TO: Kent L. Jones, State Engineer, Utah Division of Water Rights

FROM: R. Scott Wilson, General Manager Central Iron County Water Conservancy District

Date: November 9, 2011

Subject: Beryl/Enterprise Groundwater meeting

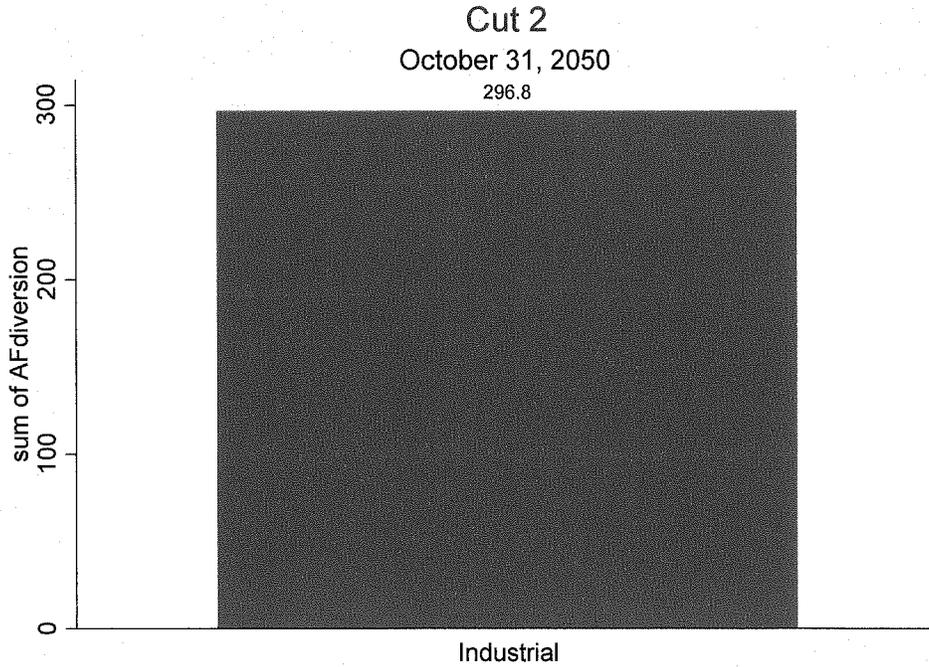
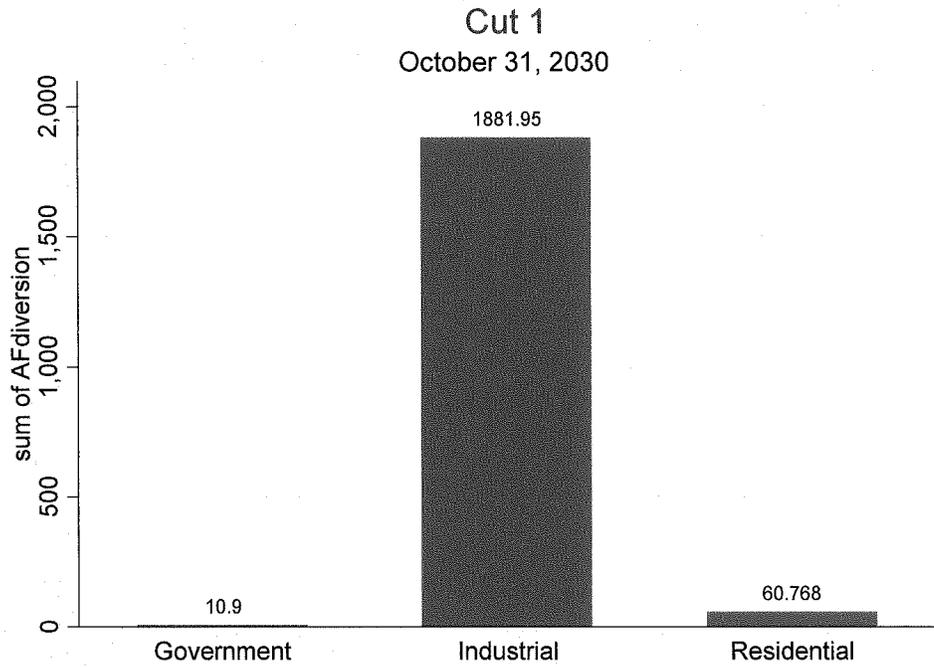
The draft plan proposes a scheduled reduction of outstanding water rights as measured by "depletion". For example in the first cut (October 31, 2030), 14,499 acre-feet of "diversions" are cut to achieve 3,355 acre-feet of "depletion". Water is typically bought and sold in the marketplace in terms of "diversions" so the draft plan's "Table 1 - Groundwater Management Plan Regulation Schedule" is misunderstood.

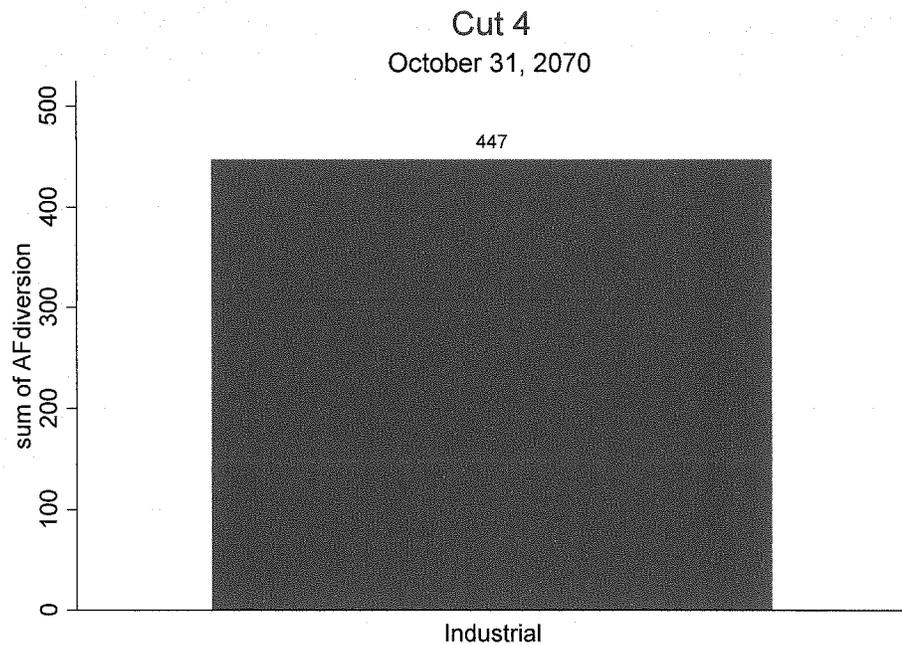
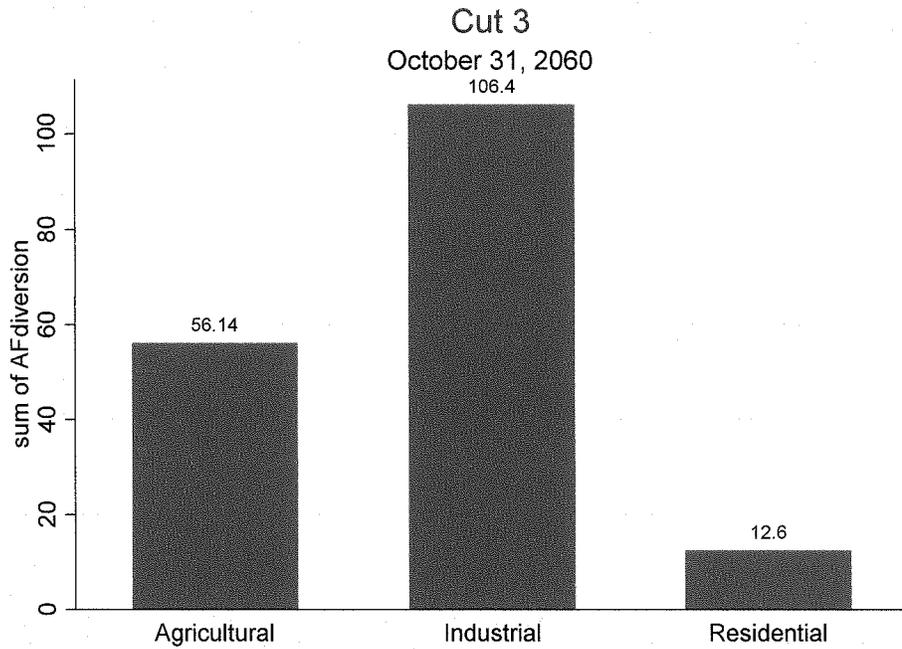
During the passage of groundwater management district legislation (SB 20, introduced and passed during the 2010 legislative session and modified during the 2011 legislative session), it was represented that a ground water management district would not impact the rail corridor contained within the Central Iron County Water Conservancy District's boundaries. However, the map on the Draft Plan clearly includes this important corridor.

- Allow for the West Side Flood channel, when developed, to bank water in this rail corridor to bank water against the Draft Plan’s scheduled reductions. An estimated 5,000 acre-feet of water annually is expected from this policy tool.
